Re: *University Station – Response to Additional Comments by Epsilon Associates*

This letter provides responses to the second round of comments from Robert D. O'Neal of Epsilon dated April 1 regarding the noise impact assessment done for University Station.

Figure 1.

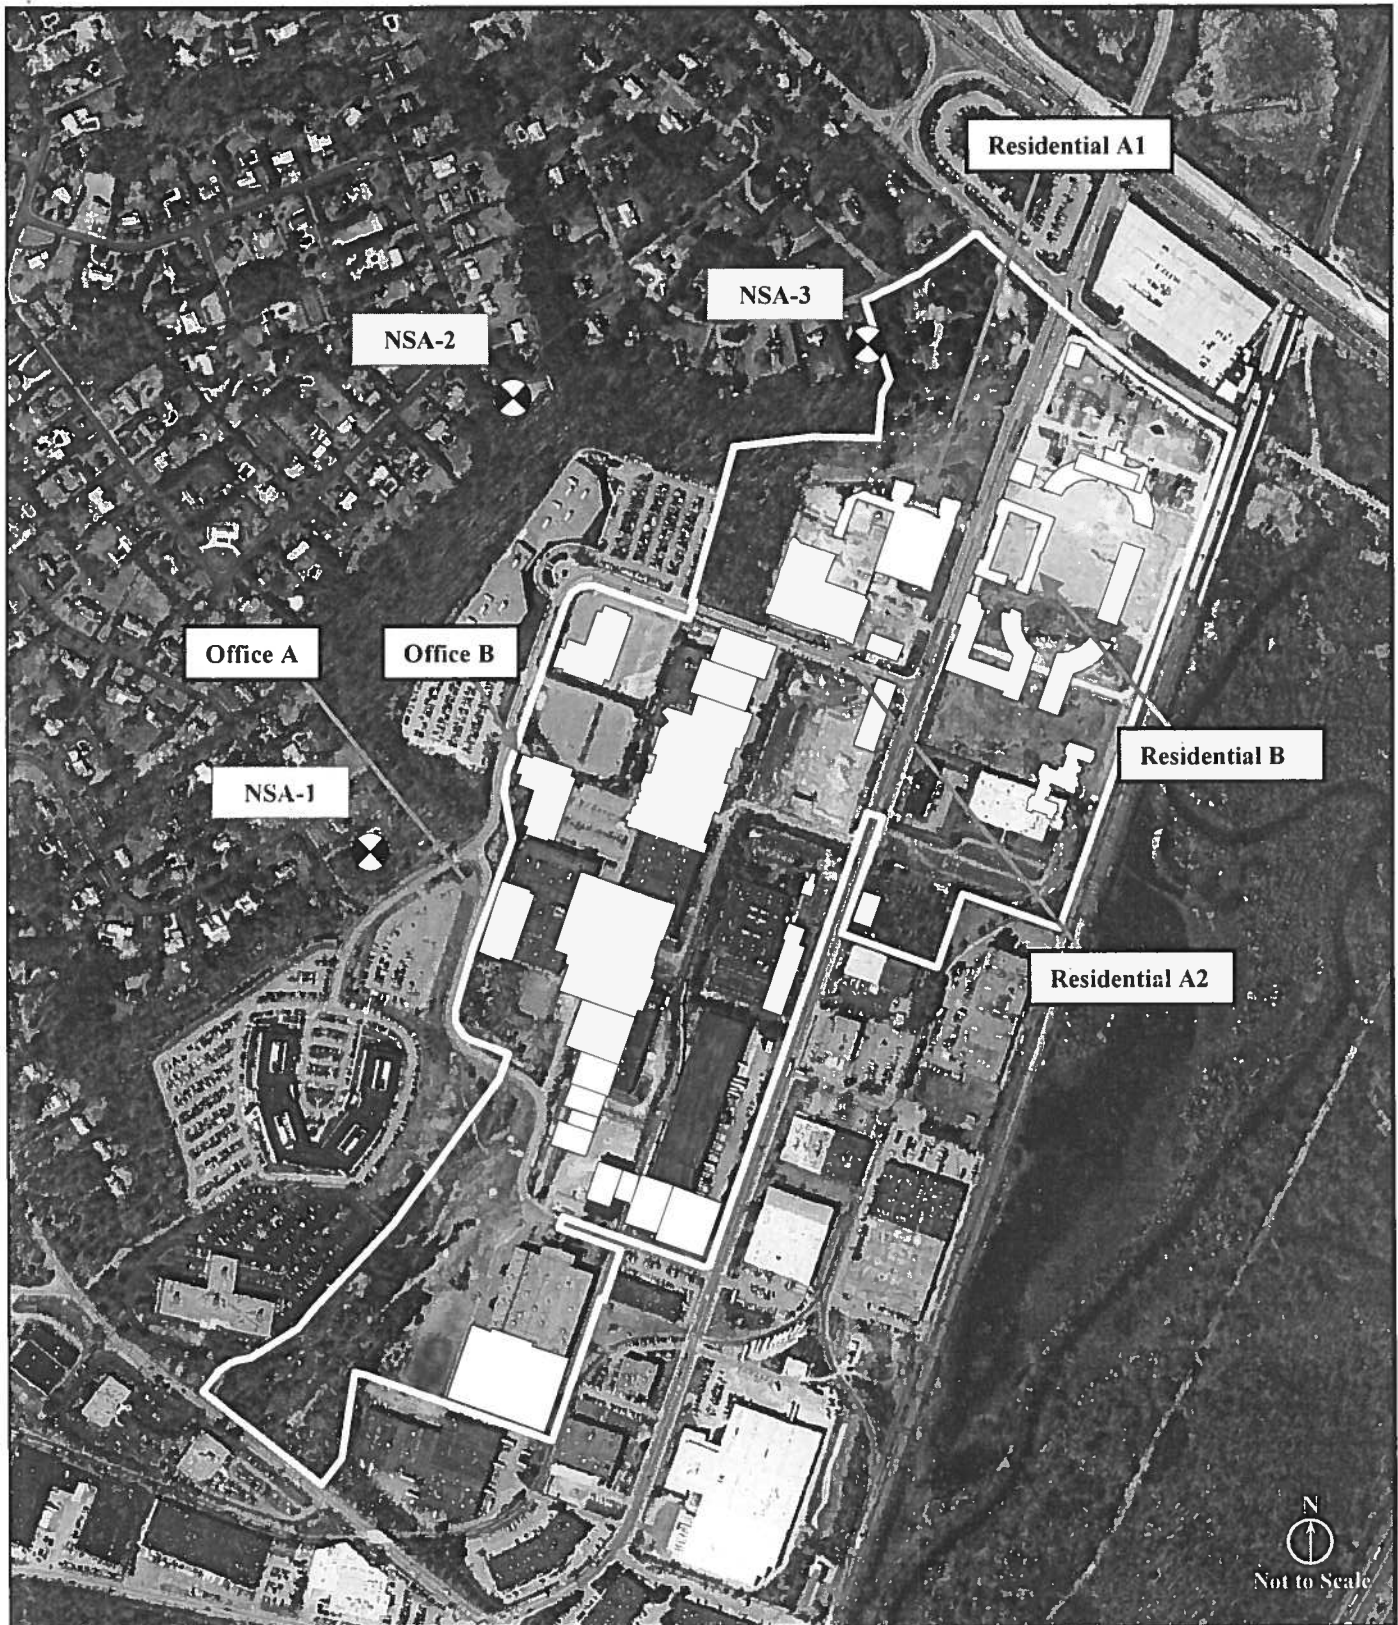
- 2. A key assumption in the impact analysis is the use of low-noise HVAC units on the two office buildings closest to NSA 1 (Office A and B), and on the three residential buildings closest to NSA 3 (Residential A1, A2, B). It is unclear which building(s) are labeled as A1, A2, and B in this analysis.**

The attached figure shows the location of Buildings A1, A2 and B.
